## **APPENDIX R**

### **Federal Lands Review**

# **PCGP Forest Service Visual Management Mitigation Analysis**

Prepared by  
Donna M. Mattson  
Consulting Landscape Architect, US Forest Service  
Reviewed by  
Christina Lilienthal, Lead National Forest Landscape Architect for the PCGP Project  
March 25, 2009

Figure 4 Google Earth view from Hwy 140

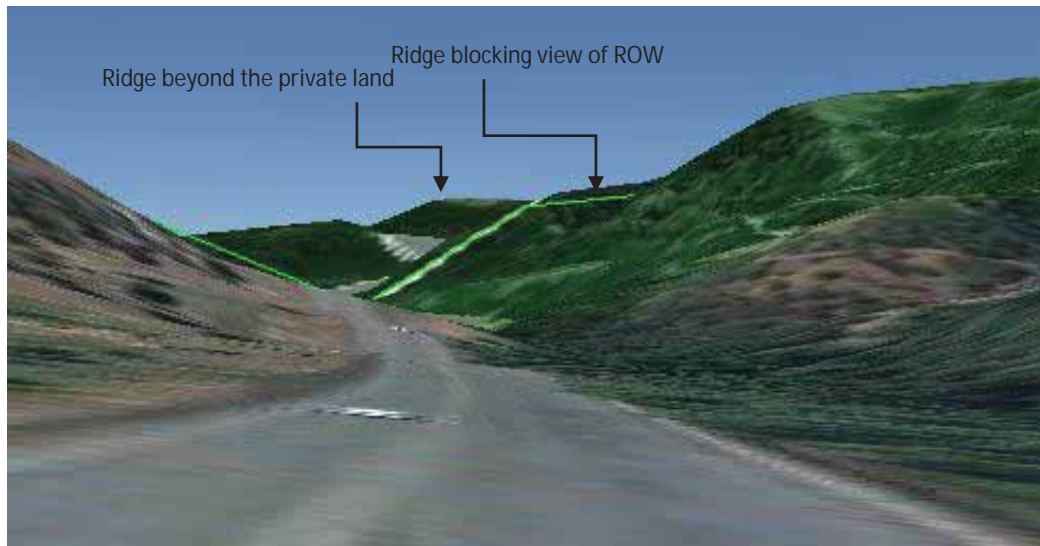
The segment **153.76 to 154.63** is screened from view by the ridge directly west.

Figure 5 View from Hwy 140 via Google Earth as taken from photo point

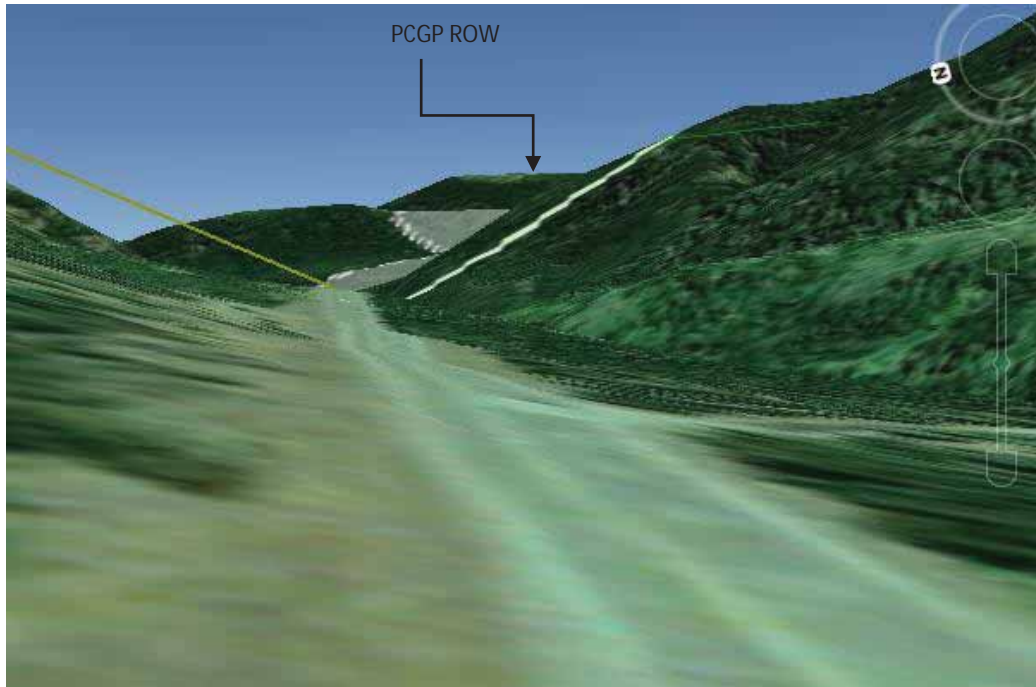
This image above (Figure 3) shows the ROW showing up on the ridge to the east of the private land which is shown in gray with the sketchy white border. The visual quality objective of this area is partial retention from the crest of the ridge down toward the highway. It appears that the ROW is back from the crest, outside of partial retention, and would not be visible.

Figure 6 Views from Hwy 140

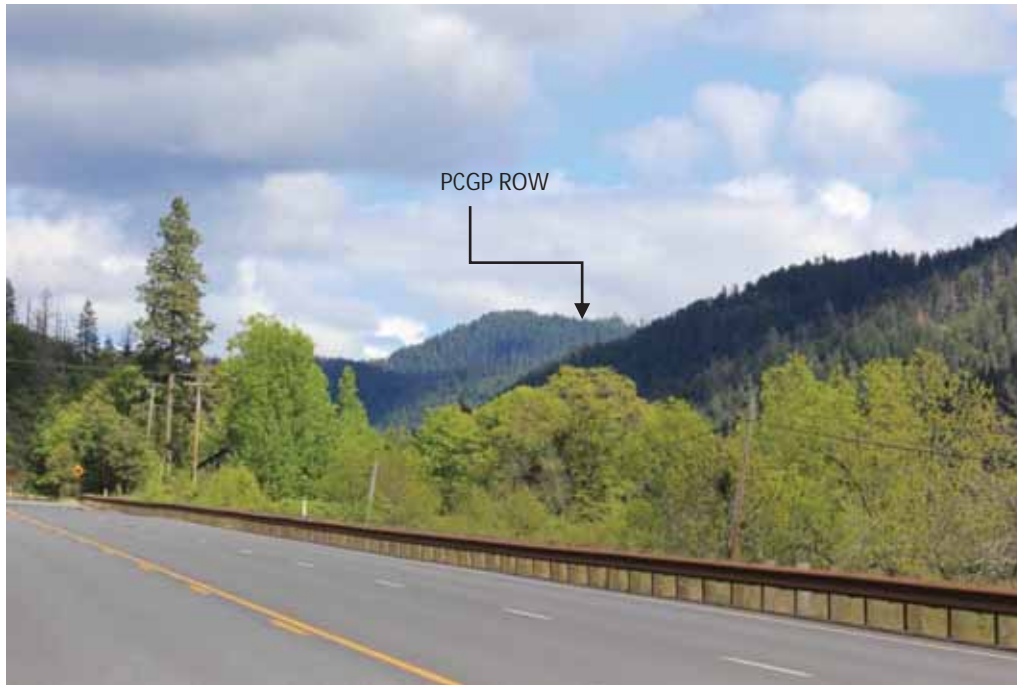
The photo below (Figure 4) shows the ridge on which the ROW would lie. The ROW, as shown in Figure 5; lies a distance ranging from 200 to 400 feet behind (south) of the crest of the ridge. This location of the ROW would allow enough room to leave an adequate screen of timber. It is expected that if this screening were retained the ROW would not be visible from Hwy 140.

Figure 9 Google Earth image of segments visible from Hwy 140

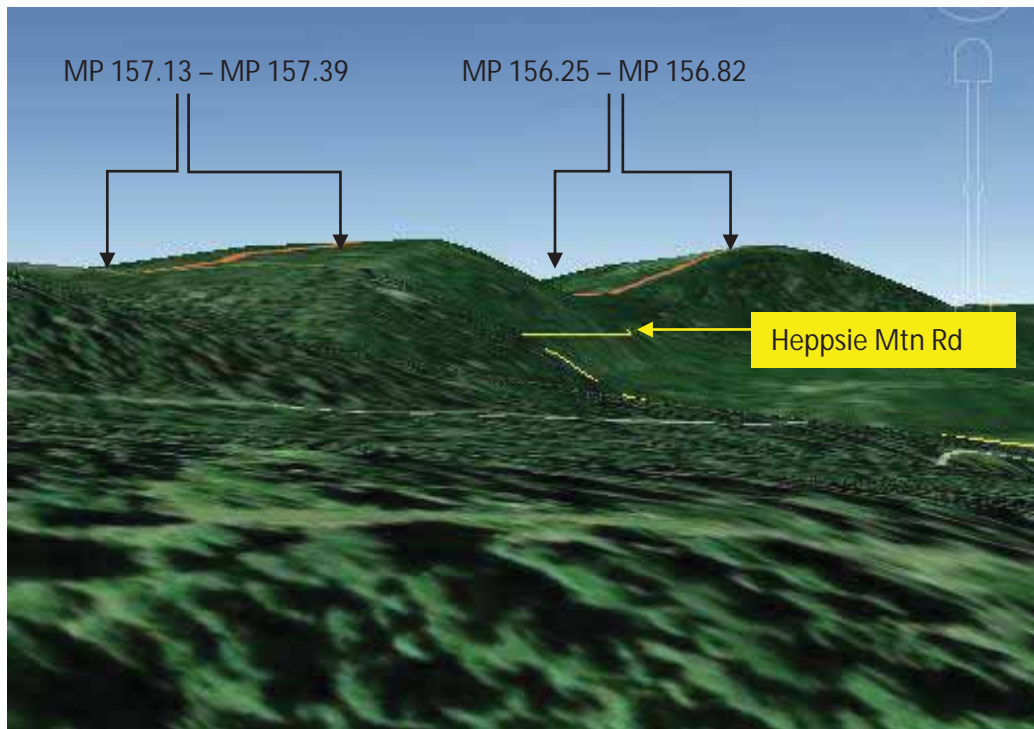
The segment **156.25 to 156.82** is located within a partial retention VOO. This segment would be visible from Hwy 140. The images below (Figure 9 & 10) show the ROW on a Google earth image and a similar view from a photo point located on the shoulder of Hwy 140. It is predicted that the visual impacts of the proposed ROW would create the equivalent of unacceptable modification at the point of project completion, (construction completed). The restoration efforts including revegetation within the 95ft ROW will eventually reduce the visual impact of the pipeline corridor. The timber on the northern edge of the ROW will eventually screen a majority of the pipeline corridor. However, the timeframe in which the visual quality objective of partial retention is to be met is within one year. (pg. 32 Natl Forest Landscape Management, Vol. 2) The vegetation screening is not expected to be in place within one year. The timber would need to reach a height of approximately 20ft to effectively screen the corridor in a manner that would reduce the visual impact enough to meet partial retention. The remaining 30ft corridor which will be "kept void of trees to facilitate corrosion and leak surveys and protect the pipeline from root damage" (ECRP) would be significantly screened and from this angle would eventually meet partial retention. The remaining 30ft corridor would essentially appear as a "straight linear gap" from the treetops in front of the ROW to the treetops behind the ROW. It is my judgement that this linear feature would be visually subordinate to the characteristic landscape.

Figure 10 Segments Viewed from Hwy 140

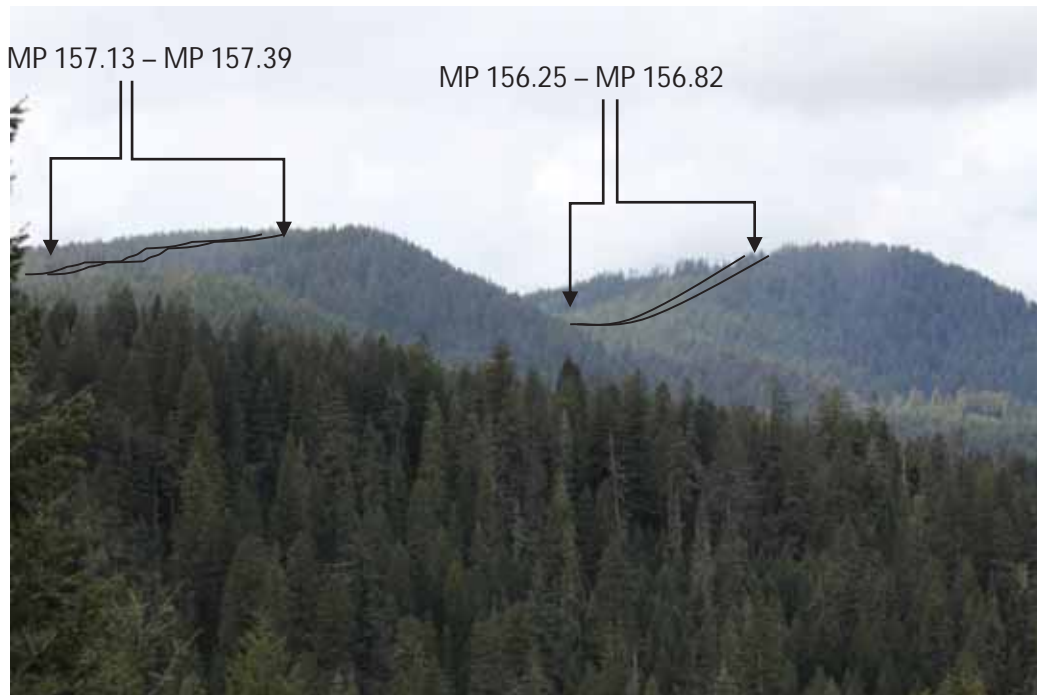
Segment **157.13 to 157.39** is also visible from Hwy 140 at an oblique angle. Prior to restoration it is expected that this segment would appear as a linear feature that would draw the eye to the area and thus the construction ROW is not expected to meet partial retention until timber in front of the 95 ft ROW reached a height of 20 feet in height whereas the remaining 30 foot corridor would be effectively screened. The remaining 30ft corridor is expected to meet partial retention due to screening of the trees to the north of the ROW. Once again, this achievement will not occur within one year of construction completion.

There are two segments (**156.25 to 156.82** and **157.13 to 157.39**) of the proposed ROW expected to be visible as shown above. These two segments lie within an area of partial retention. Partial retention is not expected to be achieved within one year of project completion. Restoration efforts are expected to eventually achieve partial retention but not within a one year period. These segments will require a site specific Forest Plan amendment for the duration in which it is necessary for restoration efforts to effectively screen the pipeline corridor.
